Date: February 27, 2025
To: Evan Wittmann
From: Jason Brûlé
Subject: Zoning By-law Amendment Application
Fariborz Fallah
924-944 King Street West, Kitchener
ZBA 25/001/K/EW

The below comments have been prepared through the review of the supplied Functional Servicing & SWM Report dated October 01, 2024 prepared by WalterFedy; in support of the above noted application.

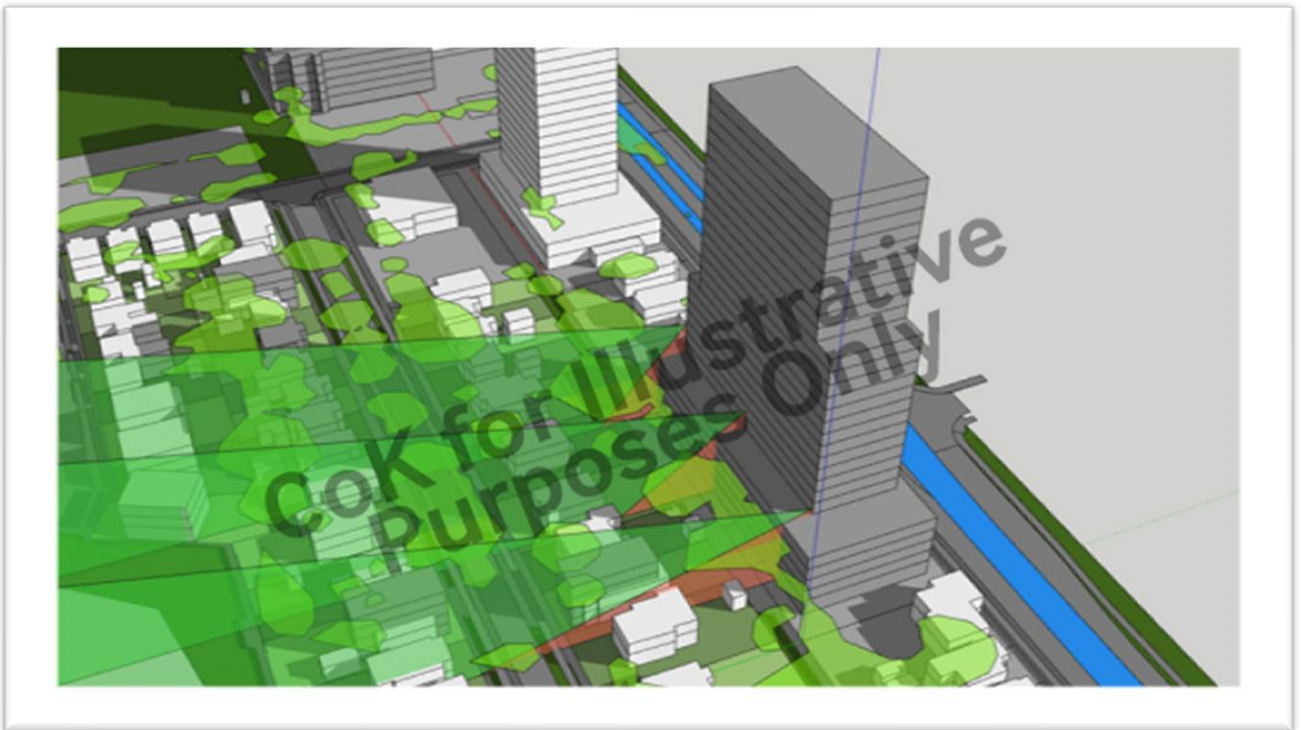
- Demonstrate the impact of sightlines from the residential units on the north side of the building. As the parking podium occupies the first 5 storeys, there may be a way to demonstrate that the impact of unit overlook is mitigated. The following image is for

demonstration purposes only, to show the kind of analysis necessary for the planning justification:

- The viewshed at the bottom of the image demonstrates that 6th floor residents cannot see into the adjacent rear-yards due to the massing and placement of the building. The middle viewshed demonstrates that 7th floor residents cannot see into the adjacent rear-yards either, but can see into the existing neighbouring buildings. This is at a combined horizontal and vertical distance of approximately 36m. The top viewshed demonstrates that the 8th floor residents can see into the adjacent rear-yards at a combined horizontal and vertical distance of approximately 32m. At the 9th floor this is also 32m, at the 10th floor it is 33, increasing from there. There is possibly a justification, using such an analysis that the proposed built form maintains at least 30m visual separation and therefore, in combination with other factors, meets the intent of the built-form transition regulation. **The above is not a formal City analysis or justification, it is provided as an example of the type of analysis and rigor that could constitute an appropriate level of justification for such significant relief from a particular regulation.**
